Cowal Gold Operations Open Pit Continuation Project Submissions Report

Prepared for Evolution Mining (Cowal) Pty Ltd
January 2024

Submissions Report

J190417 RP52

Evolution Mining
Cowal Gold Operations
Open Pit Continuation Project
Submission Report
Figure 4.1

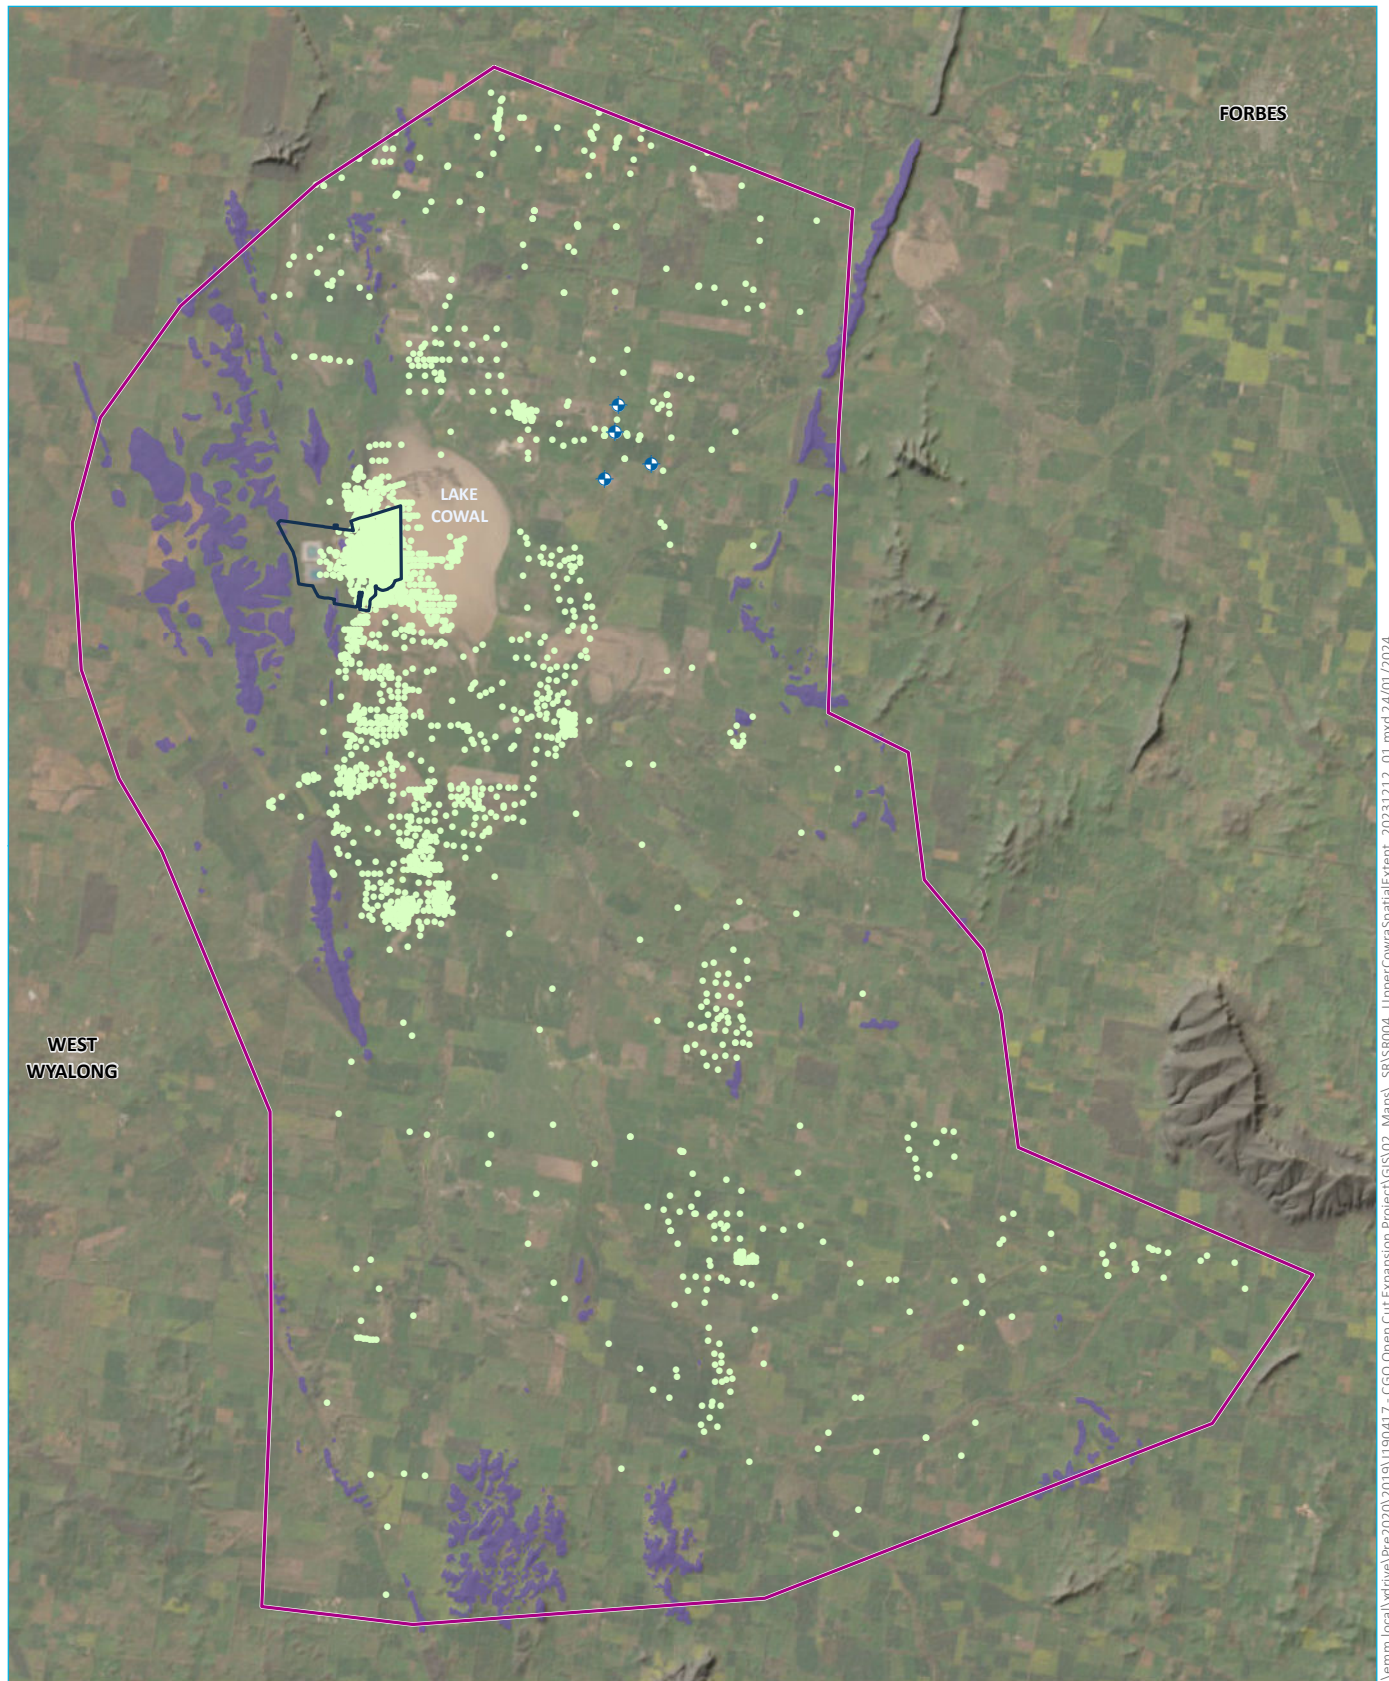
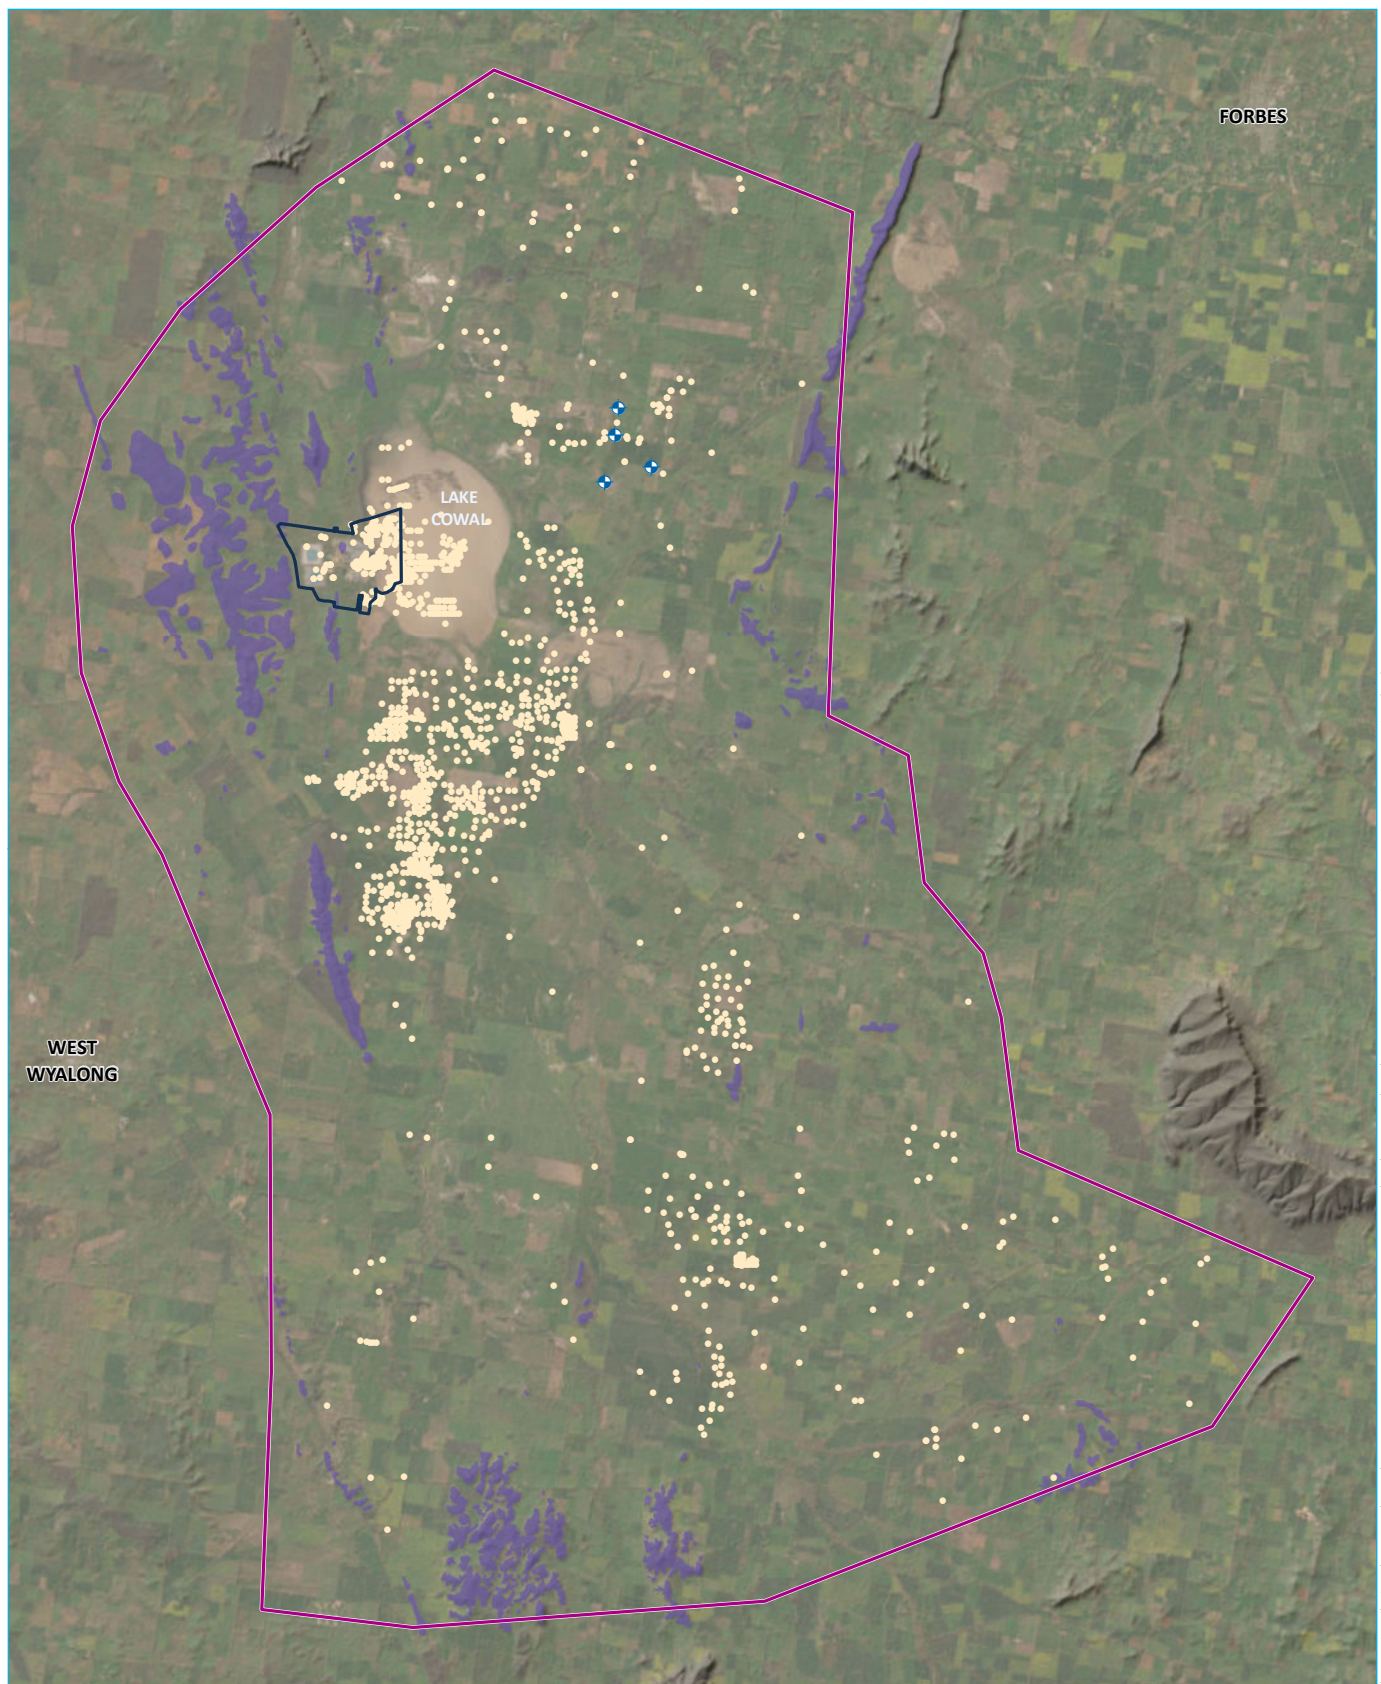
2.3 Prior to approval: Recommendation: That the proponent provides an explanation for the information gaps (i.e., absence of upper/lower layers) in the Cowra Formation aquifer system (Figures 3.10 and 3.11 of the GIA):

2.4 Prior to approval Recommendation: That the proponent provides an explanation for the gaps or absence of the Lachlan Formation aquifer 15 km to the north-east of Lake Cowal and 10 km south-east (Figure 3.12 of the GIA).

Explanation: Inactive model cells where gaps have been interpreted in the formations results in a flow barrier that may not be present and should be discussed as part of conceptual model uncertainty.

The absence of the upper/lower Cowra Formation and Lachlan Formation groundwater systems (collectively referred to as the alluvial groundwater systems) is based on:

Locations of lithological logs, indicating the presence/absence of each respective alluvial groundwater system, is provided on Figure 4.1 to Figure 4.3.

Figure 4.4 Modelled hydrographs at GW036597/1, prior to assigning drawdown multiplier (left) and following drawdown multiplier (right)

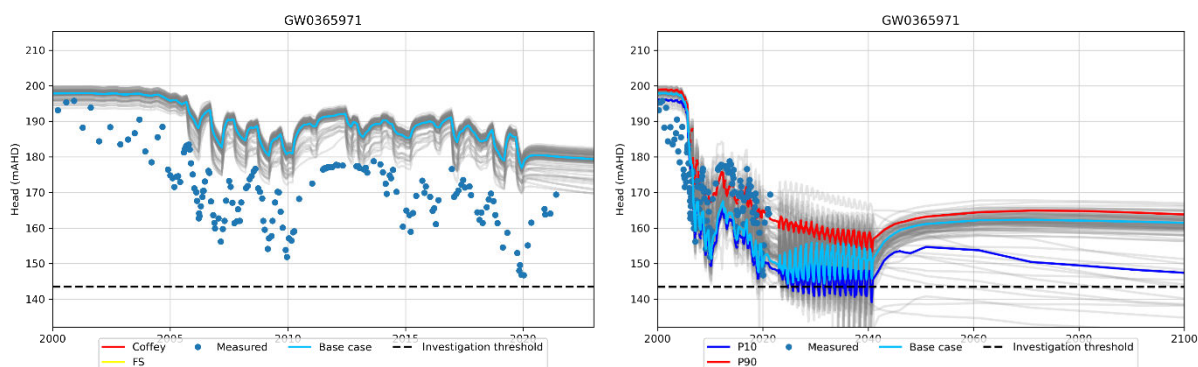
Figure 4.8 of the model report should include GW036611 and GW036597 as well as GW036553, rather than referring to those hydrographs in Appendix C of the EIS.

Additionally, the assessment of climate change impact particularly dry conditions requires inclusion in the predictive scenarios to understand the likely breach of triggers once pumping data has been updated in the model and full allocations are modelled.

Model history-matching was undertaken with the intent of minimising mismatch between modelled and measured groundwater levels and trends at 415 monitoring sites. Targets associated with compliance monitoring bores were not assigned a higher statistical weighting than those from other nearby bores and, therefore, PEST² did not attempt to achieve a better match at these locations. During the groundwater impact assessment, it was determined that the model under-represented drawdown at these locations, and therefore did not provide a conservative impact assessment. It was decided to apply a drawdown multiplier to the relevant modelled hydrographs, facilitating a more representative impact assessment without necessitating a full revision of the history-matching process. Modelled hydrograph for GW036597/1 are presented in Figure 4.4 showing the comparison before and after applying the drawdown multiplier (left and right respectively).

This additional discussion has been included in Section 5.4.1 of the groundwater modelling report. Any future history-matching will incorporate higher performance scrutiny at compliance monitoring bores, ensuring a better match to measured data and removing the requirement to use a drawdown multiplier to support impact assessment.

Figure 4.5 Modelled mine inflow predictive uncertainty analysis

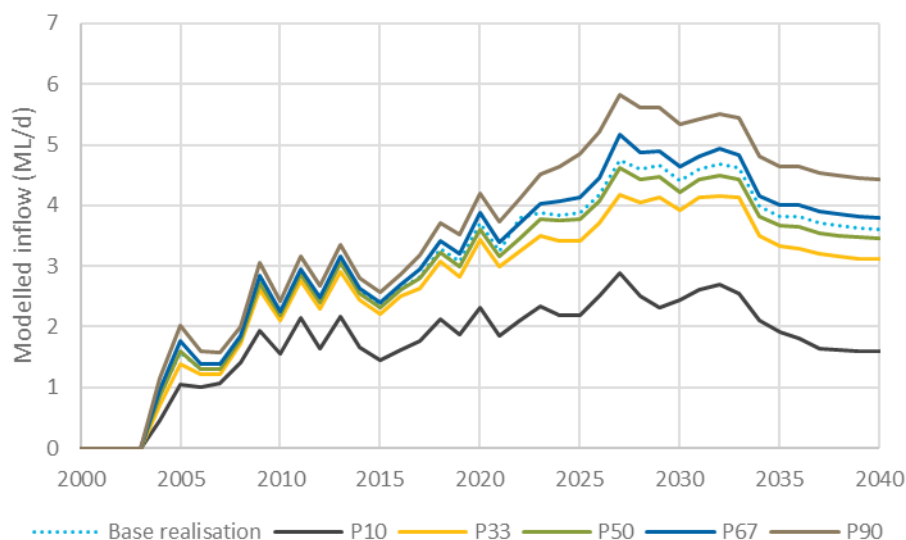
Explanation: This is required to quantify the likely uncertainty in a prediction rather than only the base realisation i.e., best fit calibrated model.

The total modelled water balance has been analysed to obtain an estimate of potential flux impact ranges. Modelled pit inflows (simulated via the DRN package) are presented in Figure 4.5, showing the base realisation and percentiles from P10 to P90. The range from P33 to P67 is fairly tight around the base realisation, with a range of approximately 0.5 ML/d above and below the base realisation in the predictive period. The P10 and P90 predictions are wider, showing total modelled peak inflow from 3 to 6 ML/d.

This discussion has been included in Section 5.2 of the groundwater modelling report. Further discretisation (e.g. inflows per pit, flux changes at Lake Cowal) require re-running of the ensemble and can be performed as part of future modelling.

Evolution Mining
Cowl Gold Operations
Open Pit Continuation Project
Submission Report
Figure 4.6

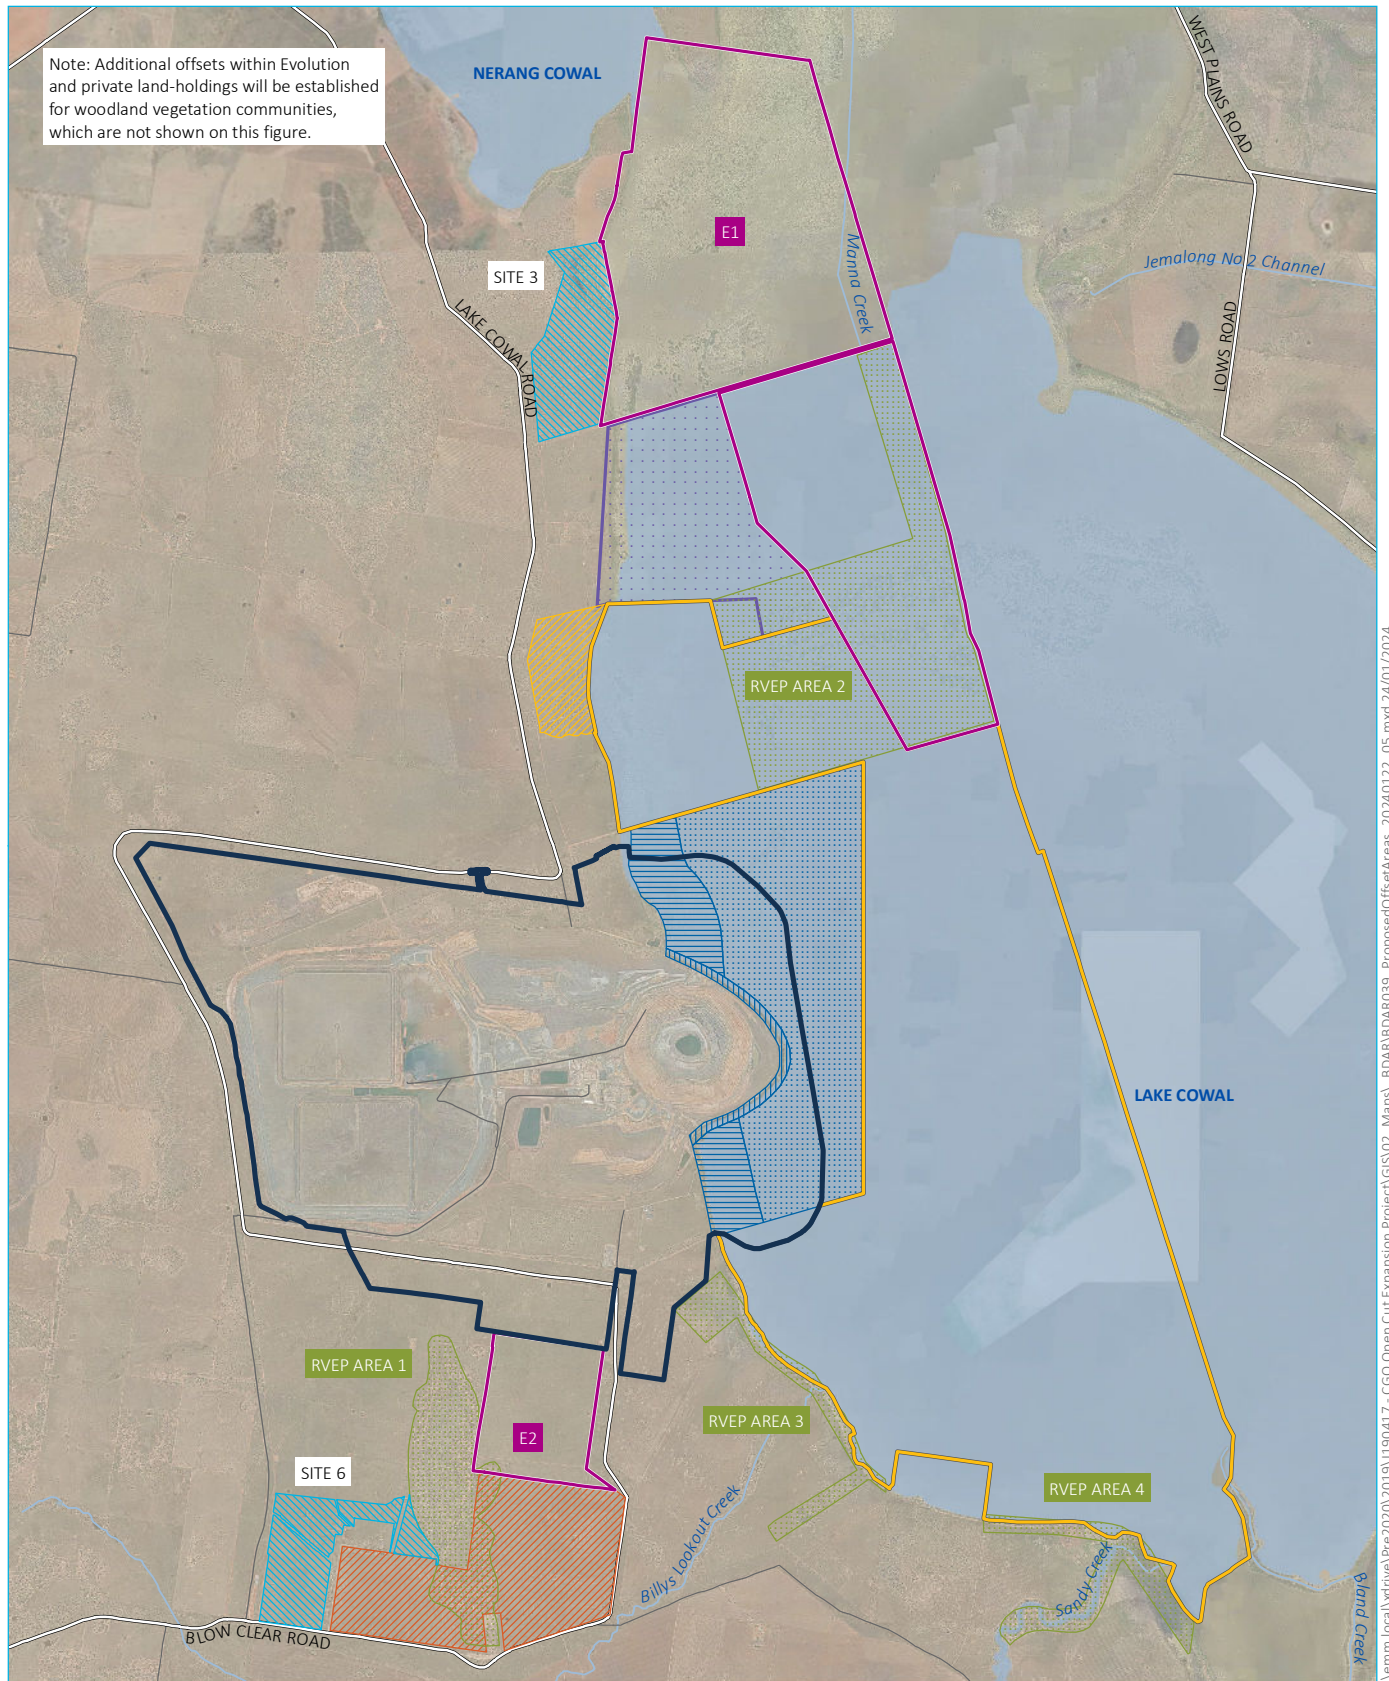
6. Impact to the Compensatory Wetland area has not been addressed

The EIS mentions the compensatory wetland area (s3.16.2) and proposes re-instatement of the lake foreshore following the concepts in the CWMP (Section 4.5.3). The BDAR reference list includes monitoring reports for the compensatory wetland areas but does not identify or include any discussion about impacts of the proposal on the area, or implications for the offsetting intent of the original consent.

Evolution's landholdings have been reviewed, and a proposed land area proposed for the establishment of a BSA to compensate for impacts to land managed under the Compensatory Wetland Management Plan is presented in Figure 4.6, alongside other proposed areas to offset impacts to wetlands.
